Village Board Meeting
Agenda
Tuesday, October 25, 2022
5:30 p.m.

TO: **Intergovernmental Agreement (IGA) Joint Commission & Village of Somers Plan Commission**
FROM: **Luke Godshall, Senior Land Use Planner**
RPT DATE: **09-27-22**
MTG DATE: **10-10-22**
RE: **Somers Bobcat**

SOMERS BOBCAT RETAIL DEALERSHIP

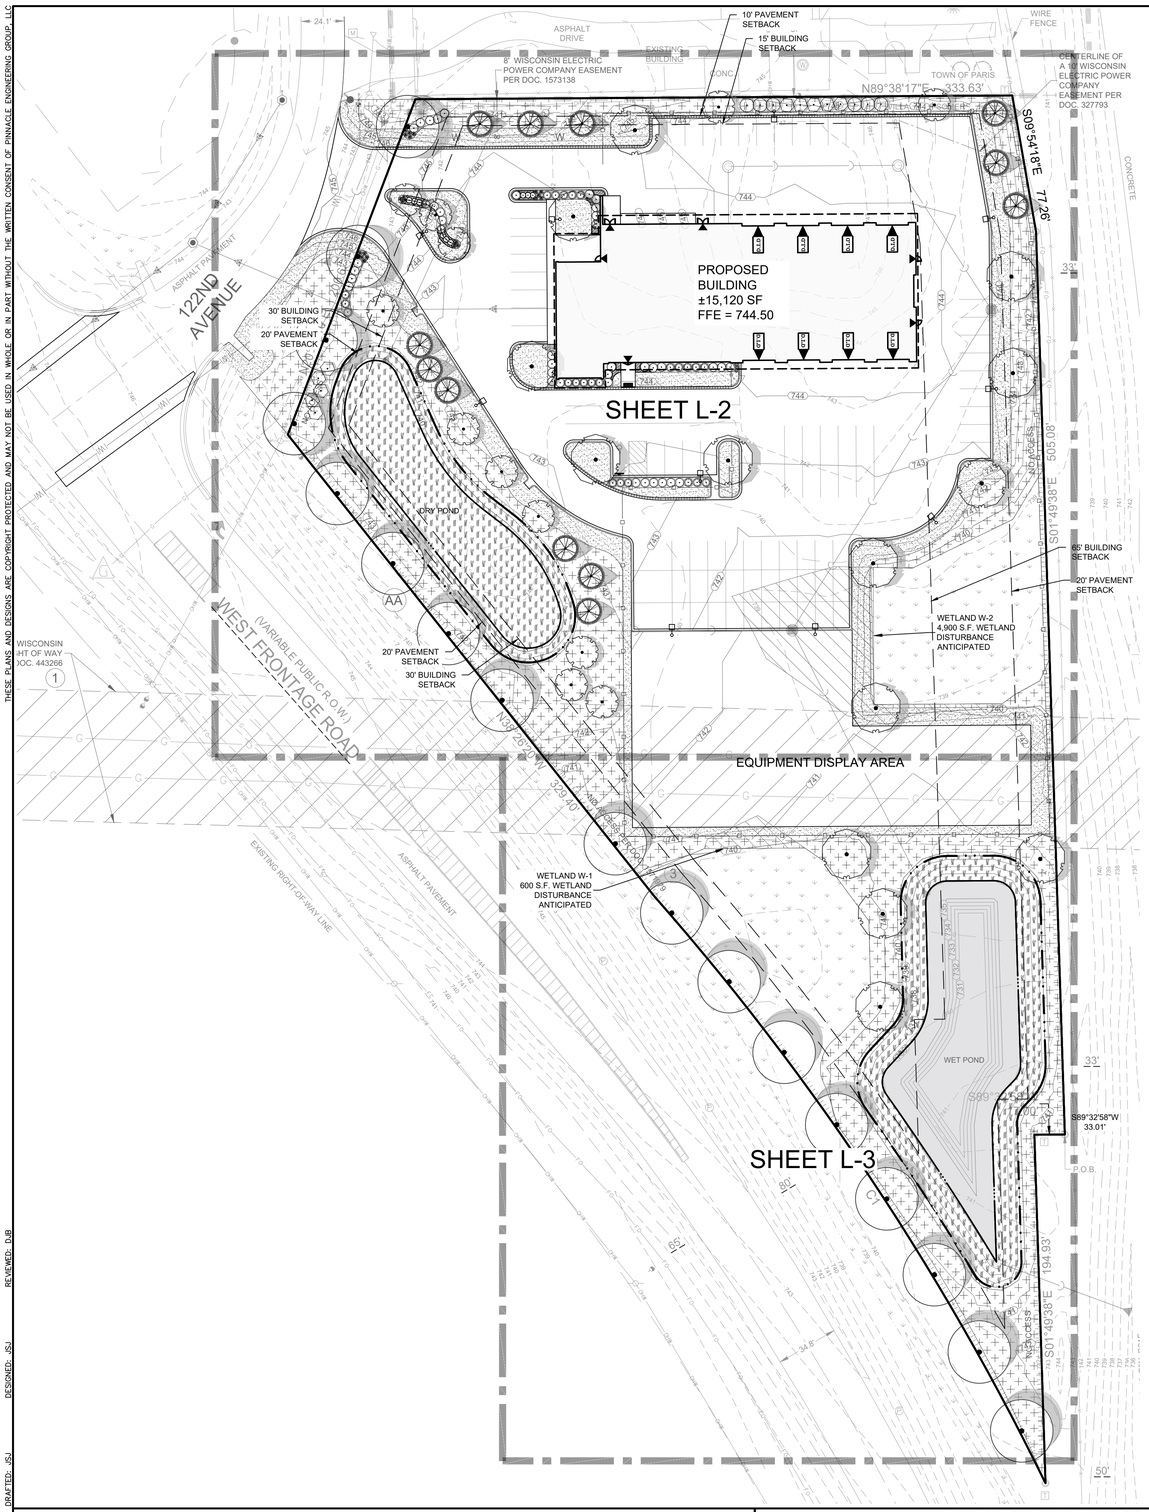
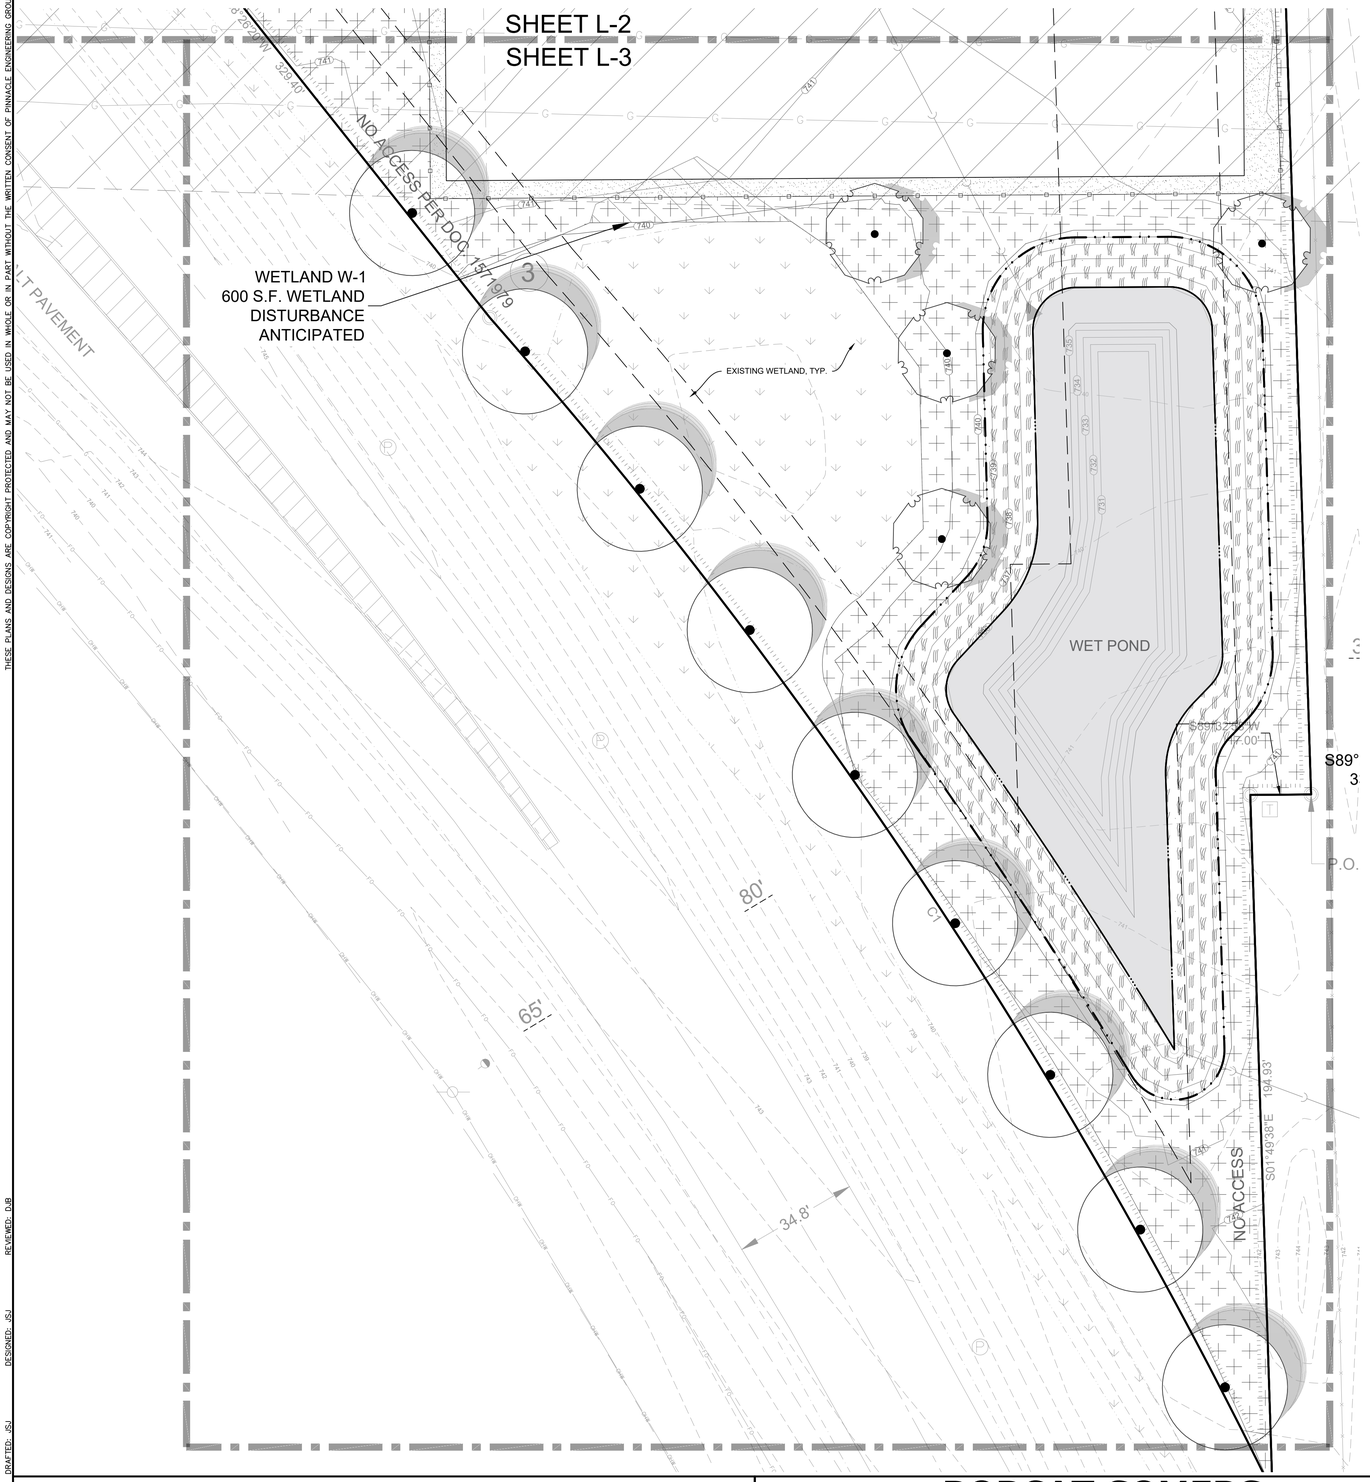
LANDSCAPING/OPEN SPACE:
The submitted landscaping plan (sheets L-1 through L-4 dated 7-18-22 by Pinnacle Engineering Group) shows compliance with Village of Somers zoning ordinance requirements. The plan meets the minimum open space requirements of both the I-94 Corridor Neighborhood Plan (25% requirement) and the Village of Somers (15% requirement). The submitted plans indicate 52.7% of the site (2.28 acre) is contained in green space.

PHOTOMETRIC SITE PLAN
SCALE: 1"=30'-0"

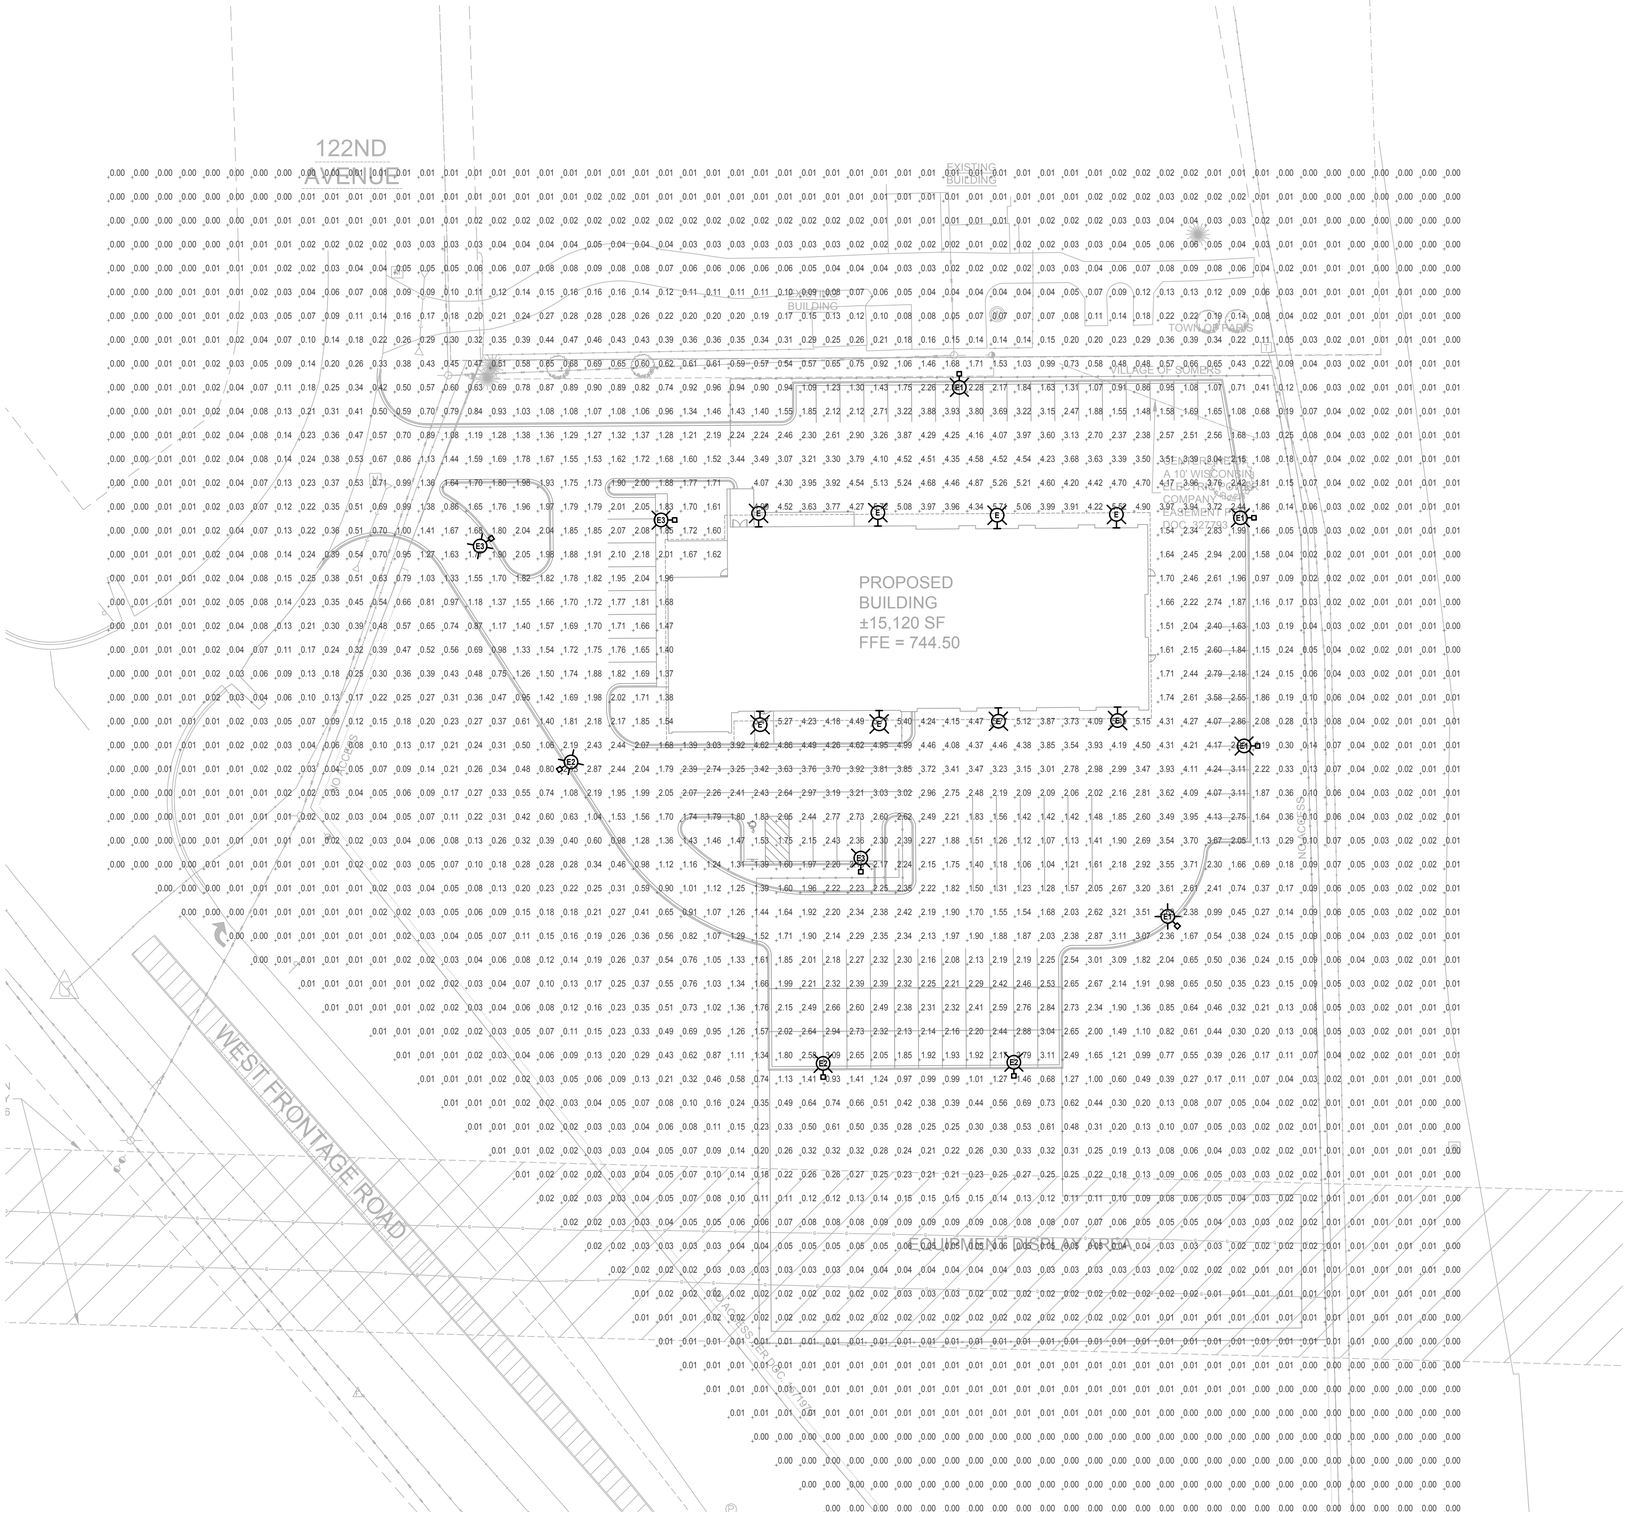
PHOTOMETRICS/LIGHTING:
A photometric site plan (dated 08-29-22 by Kornacki and Associated, Inc.) was submitted by the Petitioner and shows compliance with Village of Somers zoning ordinance requirements for light intensity (not to exceed 0.5 footcandles at property lines), fixture height (a maximum of 25' in height is permitted for parking lots serving 20 or fewer parking spaces and up to 30' in height for parking lots with more than 20 spaces), and use of fully-shielded fixtures.
